Preliminary Acceptance Punchlist

El Paso County – Department of Public Works – Stormwater Section

Project Name:	Falcon Meadows at Bent Grass Filing 3
EDARP File Number(s):	SF2216, CON2432, ASB2543
ESQCP Number:	ESQ248
Attendees:	DPW SW: Dylan Finley DPW Development Services: N/A Developer: N/a
Date of Walk-through:	07-22-2025
Walk-through Number:	1st

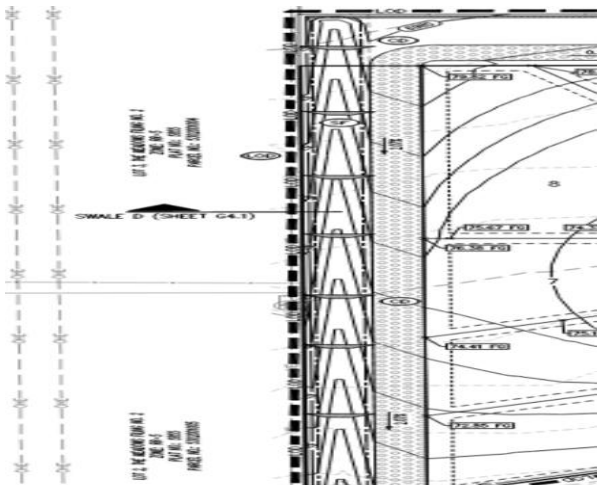
Photo 1: Swale D is not installed per plan detail, missing check dams. Install per approved plans or have the EOR must submit Engineering Record Drawings (As-Builts) reflecting any deviations from the approved plans and provide revised calculations, to be reviewed and approved by the ECM Administrator prior to Preliminary Acceptance. Reference photo 1.

Photo 4: Detail for Swale D and maintenance road for maintenance.

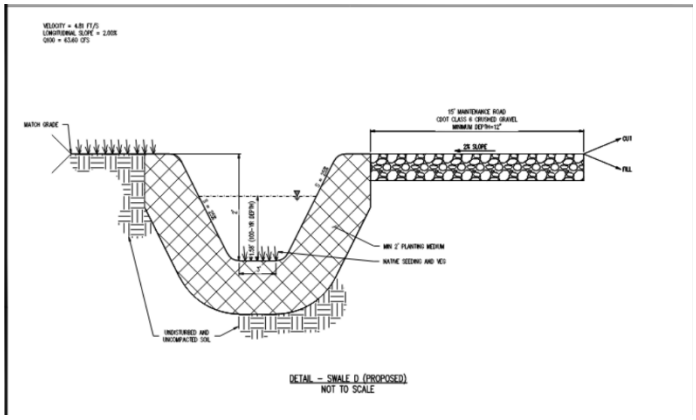
- Swale D is not installed per plan detail, missing check dams. Install per approved plans or have the EOR must submit Engineering Record Drawings (As-Builts) reflecting any deviations from the approved plans and provide revised calculations, to be reviewed and approved by the ECM Administrator prior to Preliminary Acceptance. Reference photo 1.
- Maintenance road not installed per plan detail. Install per approved plans. Reference photos 2
- Tract F and G need to be at final grade and temporarily stabilized.
- Submit a spec sheet and PO/receipt for the grass seed mix that was purchased and used.

Photo 5: Maintenance road detail for reference.

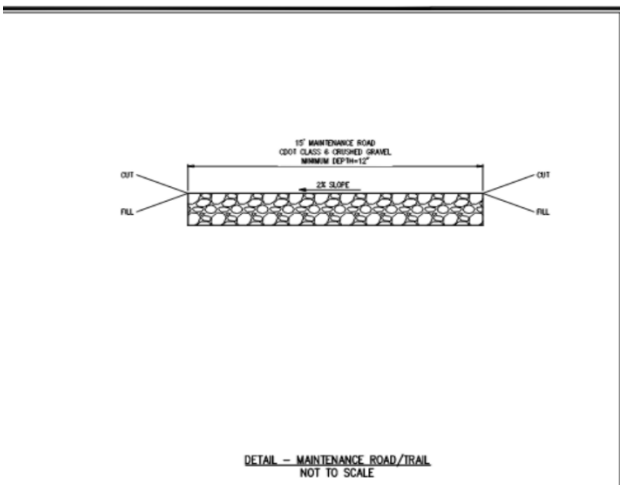
Photo 3: Maintenance road not installed per plan detail. Install per approved plans. (Highlighted in yellow.)
